Proposed change to Figure 147-5 – PCS Transmit state diagram (part b)

Proposed Changes to Figure 147-5

• Figure 147-5, line 36, Page 173

Figure 147-5—PCS Transmit state diagram (part b)

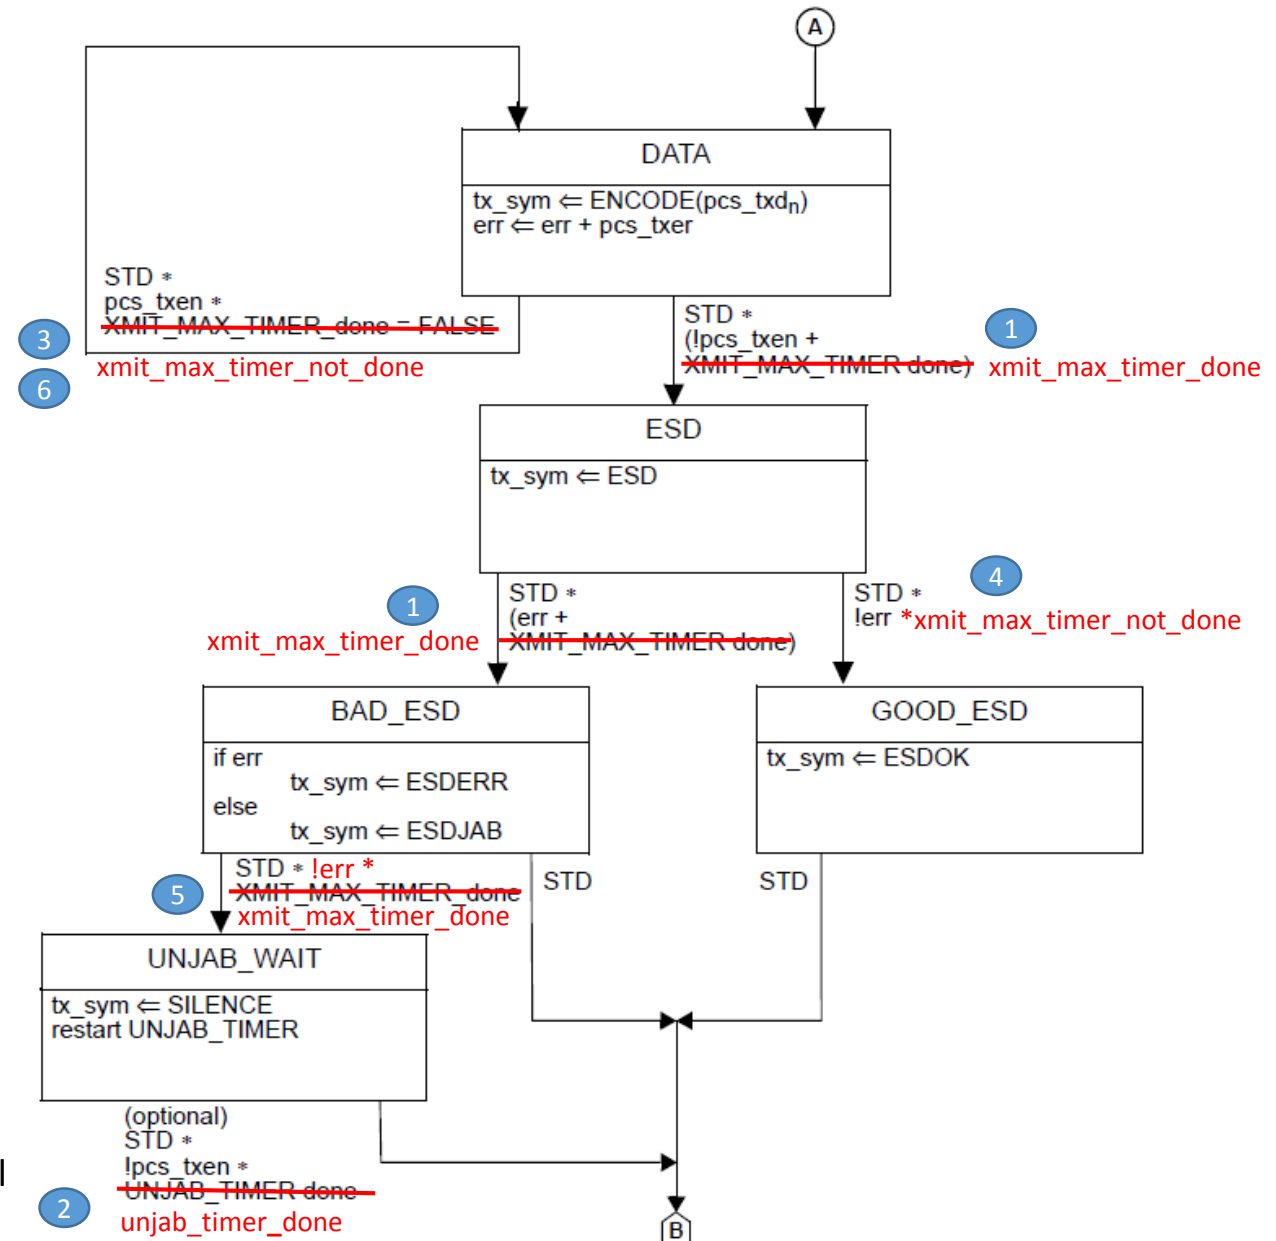
1. Use `xmit_max_timer_done` instead of `XMIT_MAX_TIMER done` and `XMIT_MAX_TIMER done`
 - Do similar changes (low case for timer) to other applicable places
2. Use `unjab_timer_done` instead of `UNJAB_TIMER done`
3. Use `xmit_max_timer_not_done` instead of `XMIT_MAX_TIMER done = FALSE`
4. Change ESD to GOOD_ESD condition from `STD*!err` to `STD*!err*xmit_max_timer_not_done`
5. Change BAD_ESD to UNJAB_WAIT condition from `STD*xmit_max_timer_not_done` to `STD*!err*xmit_max_timer_done`
6. Use “!variable” instead of “variable = FALSE” and use “variable” instead of “variable = TRUE” (e.g. Figure 148-4 on page 209, use “`plca_en`” instead of “`plca_en = TRUE`” and use “!CRS” instead of “`CRS = FALSE`”). This is a general recommendation so search in the draft specification, do similar change to applicable places

Figure 148-4—PLCA Control state diagram

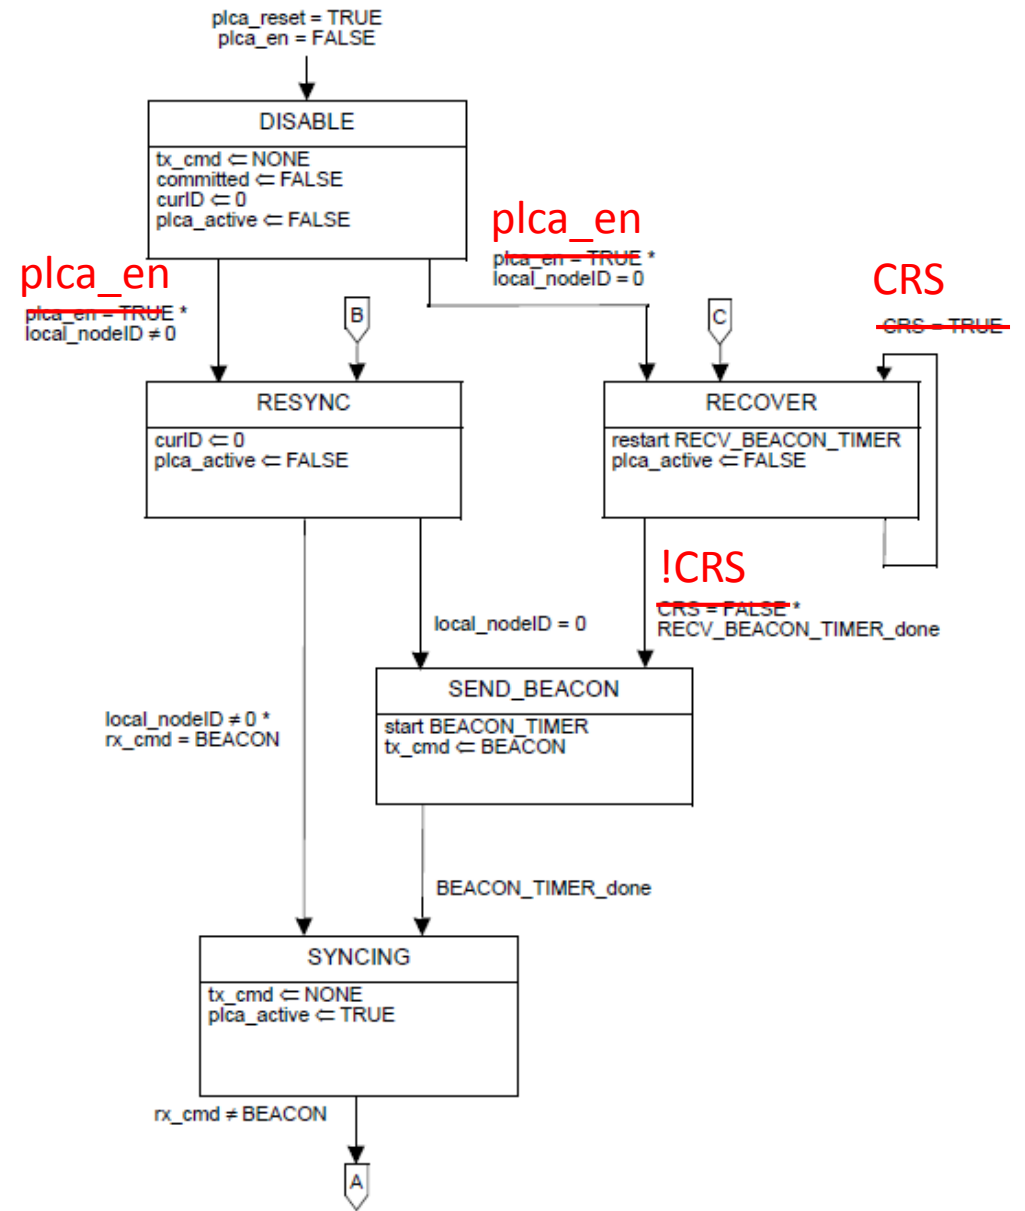
- Use “!variable” instead of “variable = FALSE” and use “variable” instead of “variable = TRUE” (e.g. Figure 148-4 on page 209, use “plca_en” instead of “plca_en = TRUE” and use “!CRS” instead of “CRS = FALSE”). This is a general recommendation so search in the draft specification, do similar change to applicable places
